Travis Perkins, St Pancras Way, Kings Cross

planning application no. 2011/1586/P

Strategic planning application stage II referral (new powers)

Strategic planning application stage 1 referral (new powers)

Fig 2: Block layout plan of buildings (source: submitted Design and Access Statement)

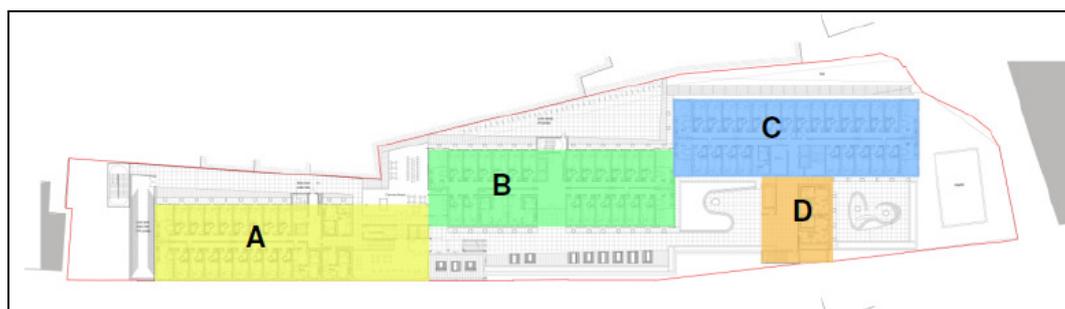
26 The student accommodation would be located above the warehouse on a podium deck. The building is arranged as four connected blocks, with the main three blocks stepping back from the road edge, and the fourth (D) comprising a perpendicular block fronting the road. At pre-application stage, the importance of breaking up the mass of the building and reducing a potential canyoning effect along the street was highlighted - this is a long narrow site with long range views afforded to it, particularly up and down St. Pancras Way. The step-backs that have evolved go some way to breaking up the imposing mass of the building onto the street, particularly at the northern end. In adopting this approach to layout, it has also enabled a series of amenity spaces on the podium roof of the warehouse building for use by the students, featuring a larger plaza type space and a more intimate amenity space at the northern end. These spaces are linked through an opening in block D, enabling links through but visual separation to be retained.

Fig 3: view from north down St Pancras Way (source: submitted Design and Access Statement)

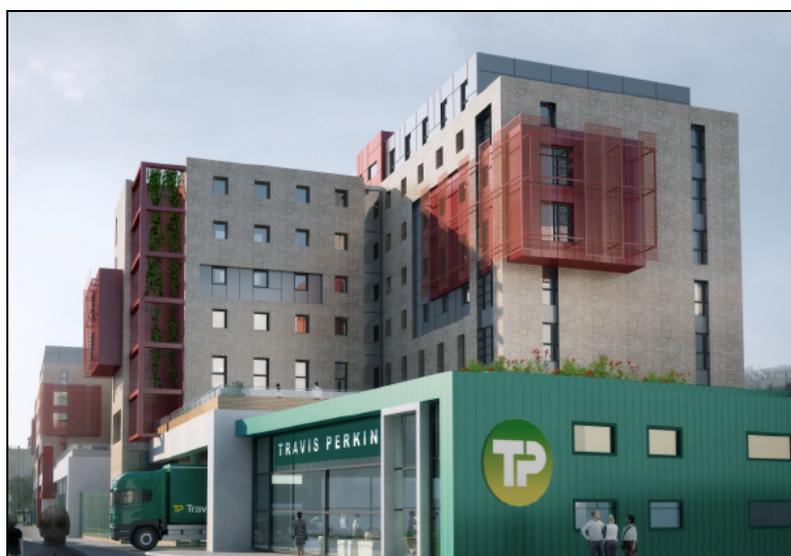
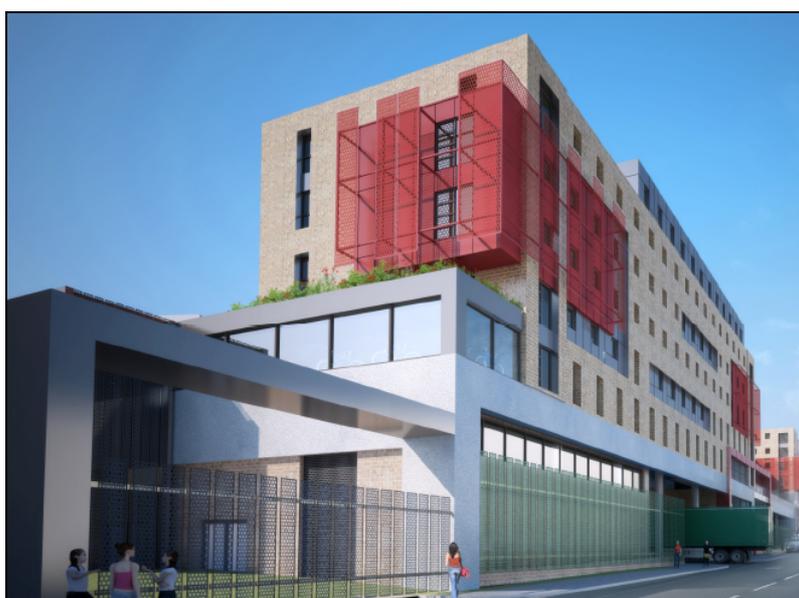
31 In the views looking north in particular, the building appears particularly dominant in the streetscene, by reason of the length of the frontage, the repetitive fenestration and the block design. There are design changes that might assist in reducing this impact, including removal of the top floor of block A and introducing a stepped arrangement at the southern end. Again, due to the modular design, it is not possible to set back the top floor from the parapet in order to reduce its visual impact. As noted above, the length of the warehouse frontage and deck, with little relief or break in its expressed frame, exacerbates the canyoning effect of the building and impact upon the streetscene.
